**ZEE Systems, Inc.**

***SERVICE LETTER***

***MODIFICATION OF MOTOR COMPRESSOR CONDENSER ASSY  
P/N: SZ45-002-1/-1A/-3/-3A WITH UPGRADED MOTOR Z99-800-1.***

FIGURE 1.

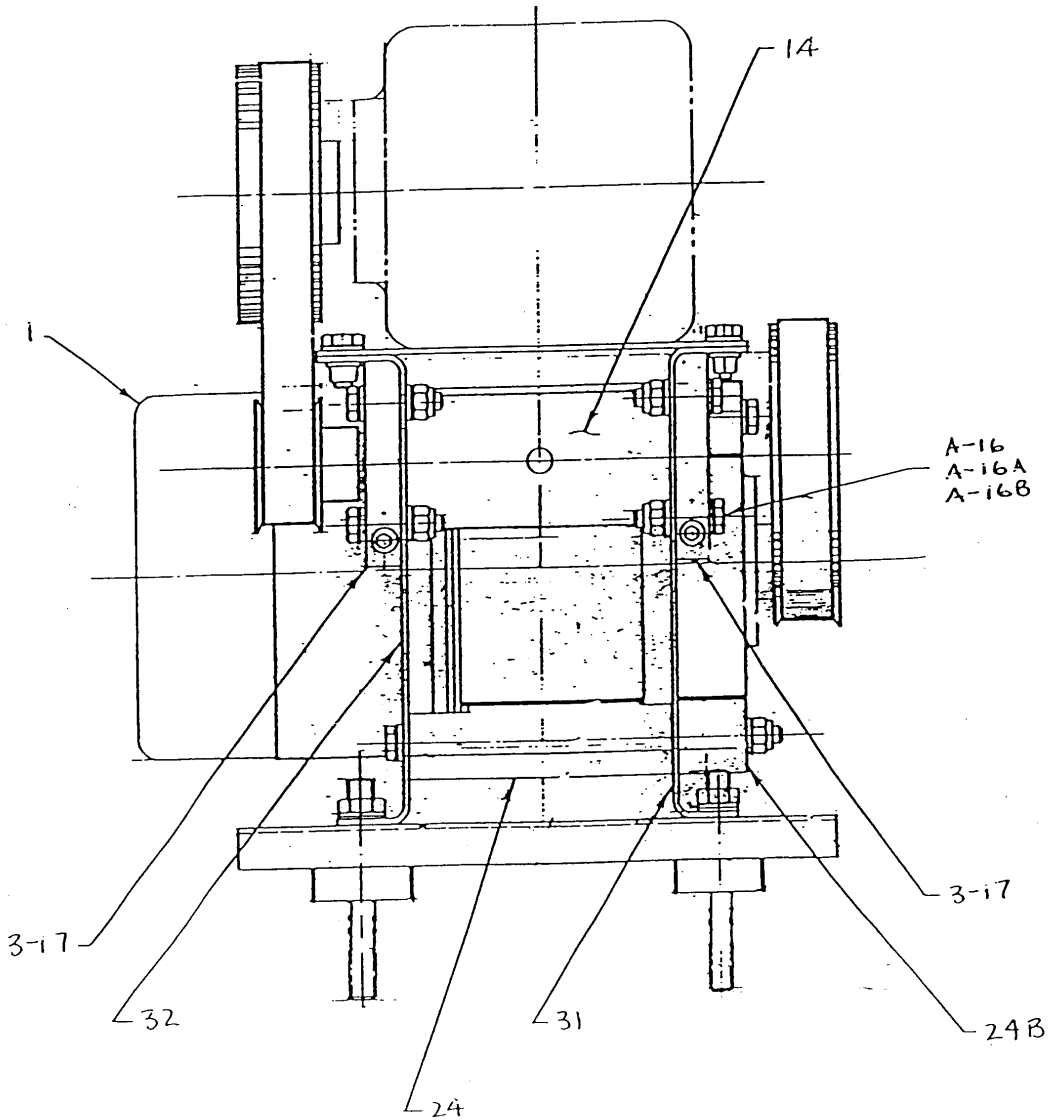
1. Attach the side frames (1-31, 1-32), tighten nuts (2-27).

2. Position and attach the two motor supports (1-24) so the long notch is away from the condenser. The two motor support extensions (1-24B) are no longer used, discard. Snug the hardware (3-34C/-34D/-34E) to hold the supports in place, do not tighten at this time.

5. Place the new drive motor loosely in the side frames and against the support pads. Make sure pads are seated against motor then tighten the hardware (3-34C/-34D/-34E) for the two motor supports (1-24). Next, align the motor adjusting bar (2-25) so the adjusting bolts are straight into the motor and snug the hardware (C-34/-34A/-34B).

FIGURE 2.

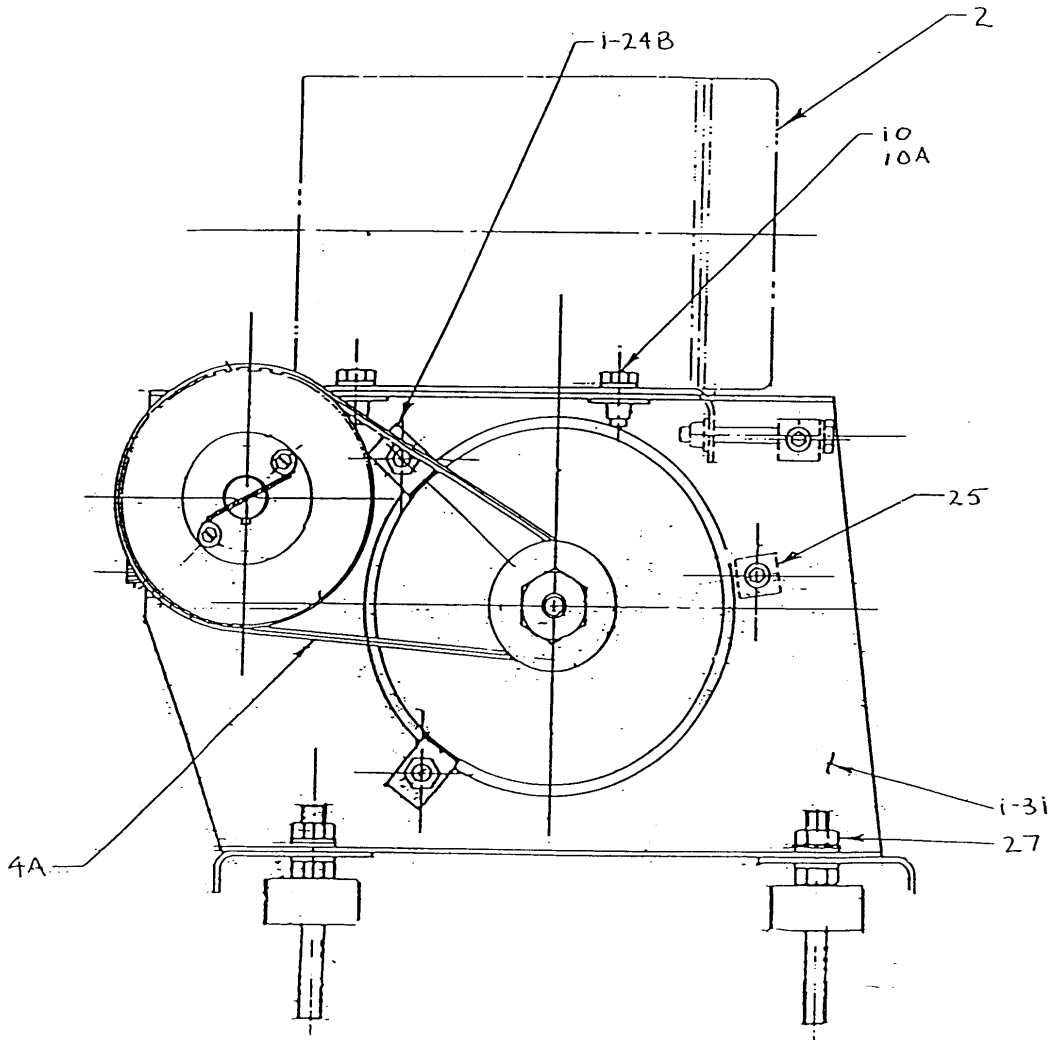
3. Position and attach the adjusting bars (3-12B, 2-25) removed in step 7 of disassembly using the hardware (B-34/-34A/-34B), do not tighten at this time.

9. Install and adjust the primary belt (2-4A) IAW SZ45MM/2.1.5.1.

10. Place the compressor plate on the side frames and loosely attach the bolts (2-10/-10A).

FIGURE 3.

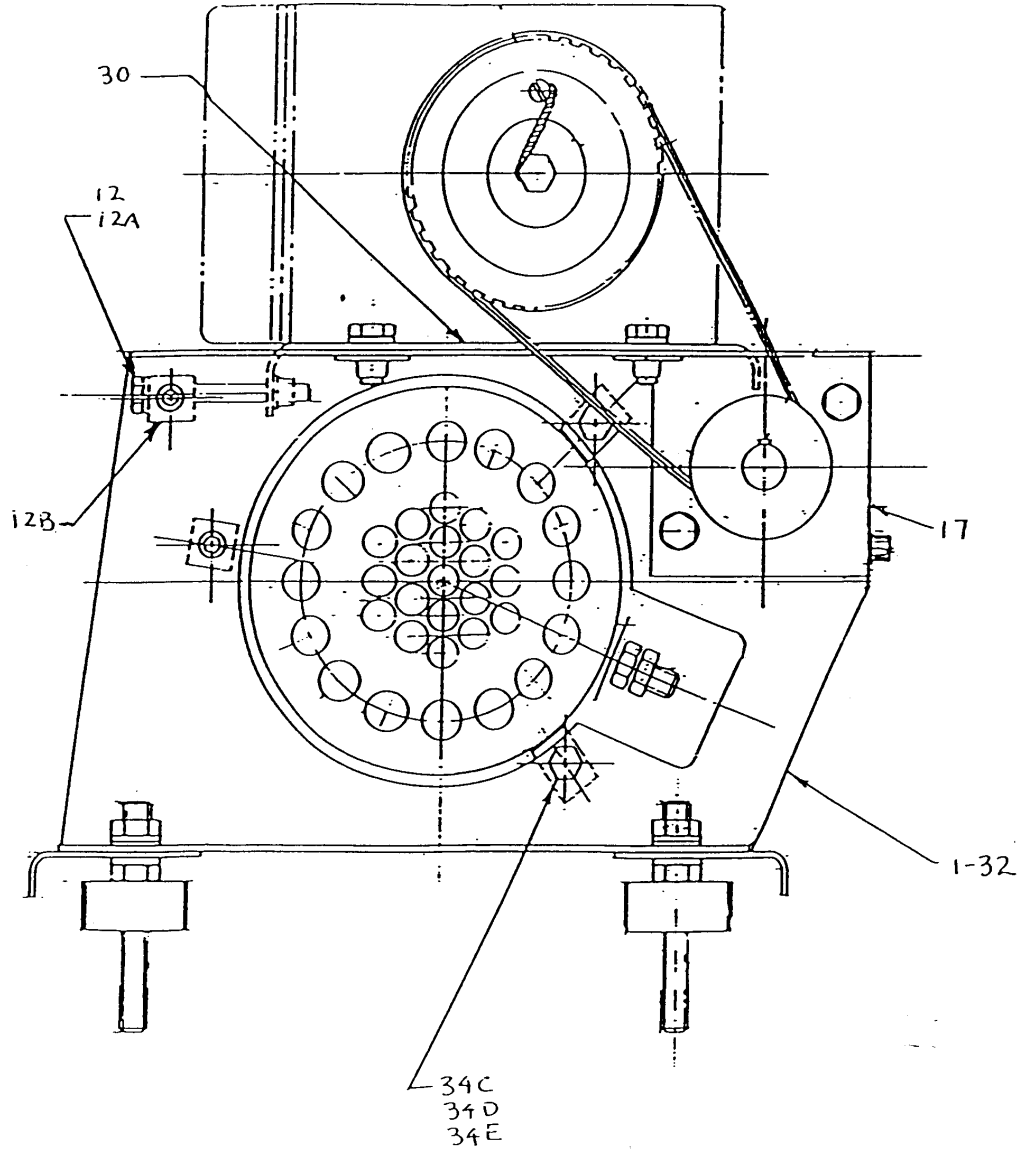
11. Slide the compressor toward the adjusting bar and start the adjusting bolt (3-12) into the compressor plate. Adjust the secondary belt IAW SZ45MM/2.1.5.2.

FIGURE 4.

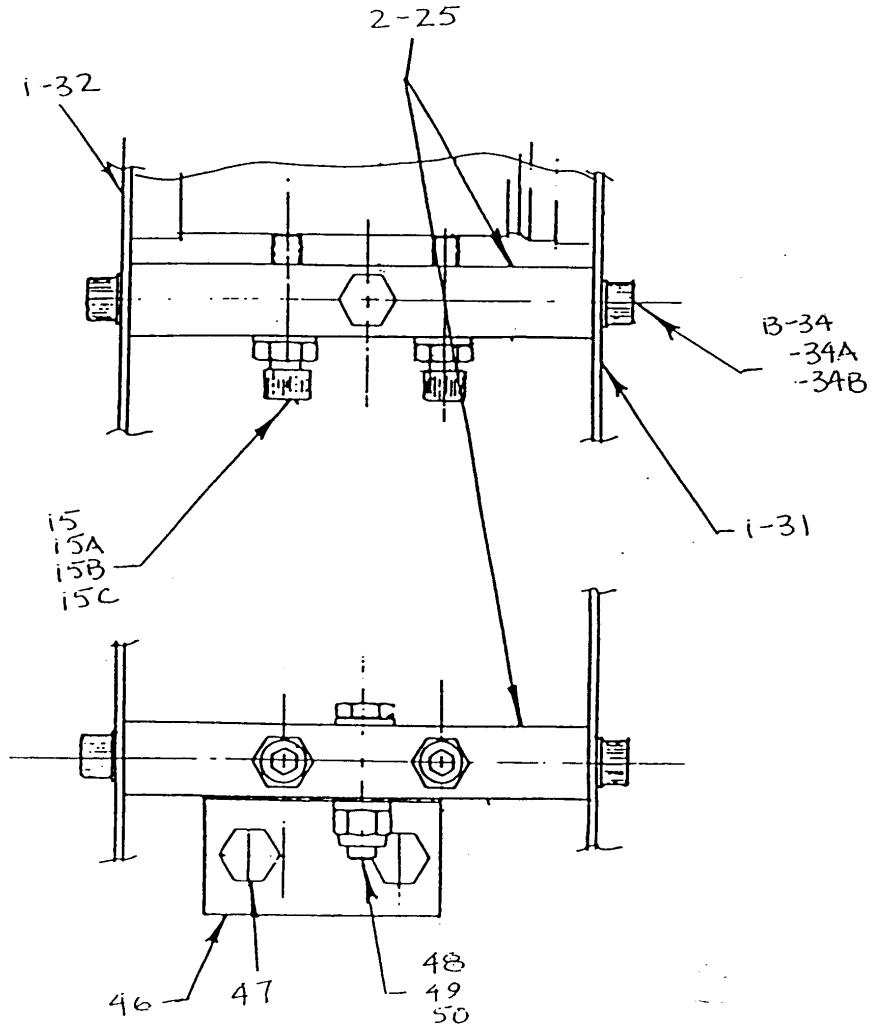
6. Attach the safety clip (4-46) to the adjusting bar (2-25) snug but do not tighten the hardware (4-48/-49/-50). There are no detents on the motor, but rather there are two drilled and threaded holes located approximately 180° opposite the electrical terminals. Loosely attach the two motor safety bolts (4-47) through the clip and into the motor. When the adjusting bar and the motor safety clip are all aligned tighten adjusting bar (2-25) and loosely attach the hardware (4-15/-15A/-15B/-15C). Make sure the motor is firmly in contact with the pads on the motor supports, this will insure the three point mount of the motor. Now, evenly finger tighten the motor mount locking bolts (4-15). Check the mounting points then tighten the two mounting bolts (4-15) and torque to 20 inch-pounds, then tighten the lock nuts (4-15A). Tighten the safety clip (4-46) to the bar and then the motor safety bolts (4-47) and torque to 20 inch-pounds.
